Access Compliance Report

Public Rights-of-Way

(Curb Ramps)

Intersection ID: 53897	Main Street: ELGIN_MOOR_RD	Cross Street: DALLAS_BAY_RD	Location: NW
ADA ID: 4B719F6D15D8	Ramp Type: BlendTrans1	Initial Pass/Fail: Fail	Overall Compliance: No
		Severity Score: 33.75

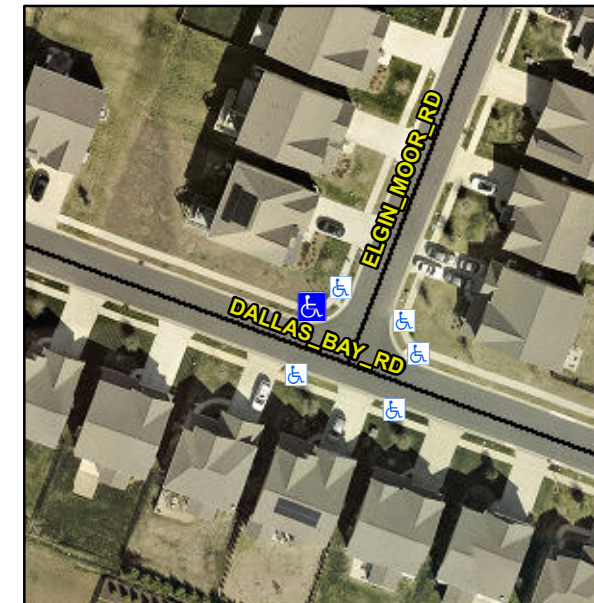
Not Found, R304.5.1, R304.5.3

Compliance	Description	Data	Compliance	Description	Data
N/A	Ramp Length (in)	50.0	Yes	BlendTrans Slope (%)	1.2
No	Ramp Width (in)	45.0	No	BlendTrans XSlope (%)	10.1
N/A	Flare Type LT	N/A	N/A	Flare Type RT	N/A
N/A	Flare Slope LT (%)	N/A	N/A	Flare Slope RT (%)	N/A
N/A	Flare Traversable LT?	N/A	N/A	Flare Traversable RT?	N/A
N/A	Landing Length (in)	N/A	N/A	DWS Provided?	N/A
N/A	Landing Width (in)	N/A	N/A	DWS Contrast?	N/A
N/A	Landing Slope (%)	N/A	N/A	DWS Length (in)	N/A
N/A	Landing X Slope (%)	N/A	N/A	DWS Full Width?	N/A
N/A	Landing Curb? (Y/N)	N/A	N/A	DWS Offset (in)	N/A
N/A	Shared Landing?	N/A			
N/A	Gutter Ponding?	N/A	N/A	Gutter Slope (%)	N/A
N/A	Gutter Lip Ht (in)	3.0	N/A	Gutter X Slope (%)	N/A
N/A	Painted X Walk1?	No	N/A	Painted X Walk2?	N/A
	X Walk 1 Direction	To SW		X Walk 2 Direction	N/A
	X Walk 1 Width (in)	N/A		X Walk 2 Width (in)	N/A
	X Walk 1 Slope (%)	4.0		X Walk 2 Slope (%)	N/A
	X Walk 1 X Slope (%)	5.1		X Walk 2 X Slope (%)	N/A

N/A	Ramp inside XWalk1?	N/A	N/A	Ramp inside XWalk2?	N/A
	Road Slope (%)	5.1		Clear Space?	N/A
	Road X Slope (%)	4.0	N/A	Clear Space to XWalk (in)	N/A
N/A	Any Obstructions?	N/A	N/A	Storm Grate/Utility Hazard?	N/A
	Obstruction Type			Storm Grate/Utility Type	
		N/A			N/A
			Yes	Surface Condition? (G/P)	Good
			No	Curb Slope (%)	15.9

Remove & Replace Curb Ramp With Two New Directional Ramps or Equivalent.
